Work Order ID 133389

Item ID: D350-607-511 Accept ***N900040100*** Setup Start ***NS1***
 Revision ID: Stop ***NS2***
 Item Name: Quick Release Basket and Long Cargo Tube Mounting Provisions, Fits LH or RH
 Start Date: 6/02/15 Start Qty: 2.00 ***2*** Cust Item ID:
 Required Date: 6/08/15 Req'd Qty: 2.00 ***2*** Customer:
 Reference:

DART SERVICE INSTRUCTION

TO AMEND INSTALLATION INSTRUCTIONS D350-607-3 Rev.D,
INSTALLATION INSTRUCTIONS D350-607-4 Rev. C AND
INSTRUCTIONS FOR CONTINUED AIRWORTHINESS ICA-D350-607 REV. 6
REF TCCA STC: SH94-14
REF FAA STC: SR00213NY
REF EASA STC: EASA.10016996
REF BRAZILIAN STC: 2007S03-03/-04/-05/-06

FIGURE 1: INSTALLATION OF D4775-041 FWD STRUT

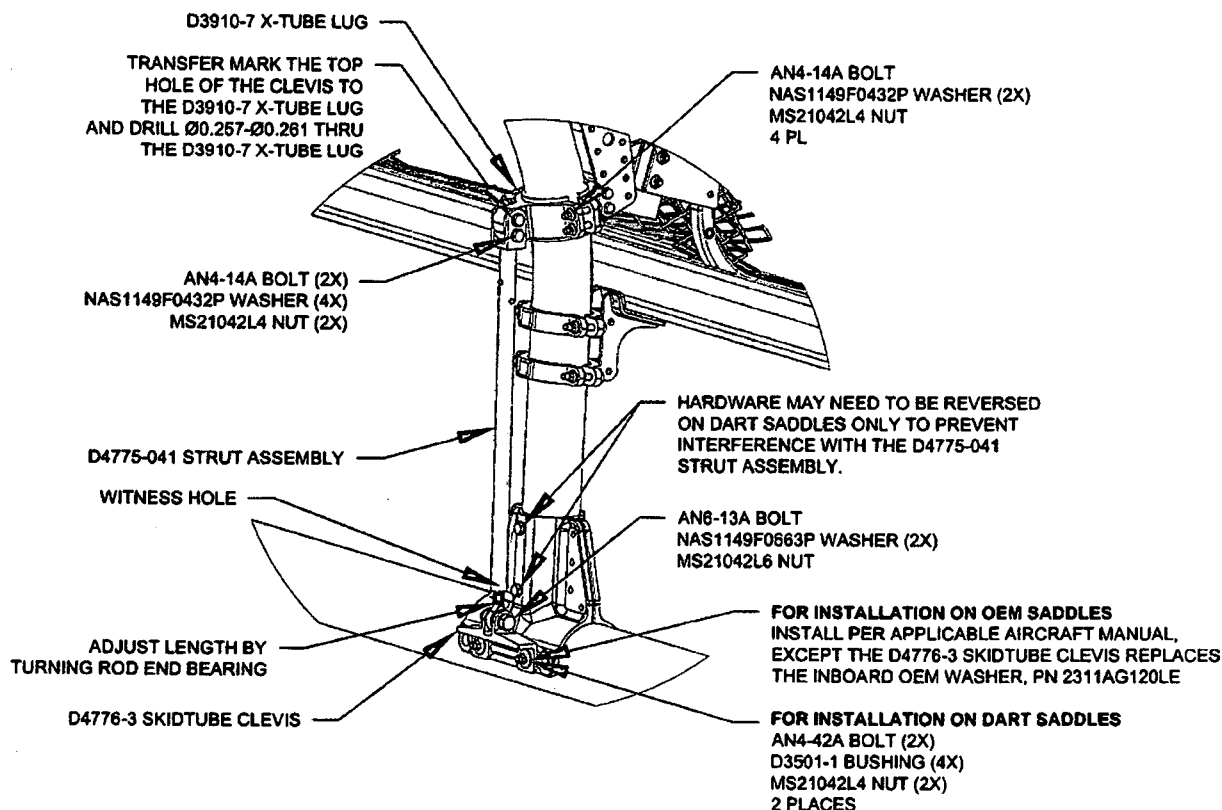
- 3.1 Substitute the Forward Lower D3910-5 X-Tube Lug with the D3910-7 X-Tube Lug as shown in Figure 1.
- 3.2 Install the forward D4775-041 Strut Assembly. Transfer mark from the upper hole on the clevis of the D4775-041 Strut Assembly to the D3910-7 X-tube Lug and drill thru the lug $\varnothing 0.257$ - $\varnothing 0.261$ as shown in Figure 1. Touch up chemical conversion coating per MIL-DTL-5541. Check the witness holes located at the bottom end of the D4775-041 Strut Assemblies to ensure that the thread from the rod end extends past the witness hole.
Torque MS21042L4/-4 nuts to 50-70 in-lbs (5.7-7.9 N-m). Torque MS21042L6/-6 nuts to 160-190 in-lbs (18.1-21.5 N-m).
- 3.3 Complete the installation in accordance with Installation Instructions D350-607-3 Rev. D or D350-607-4 Rev. C.
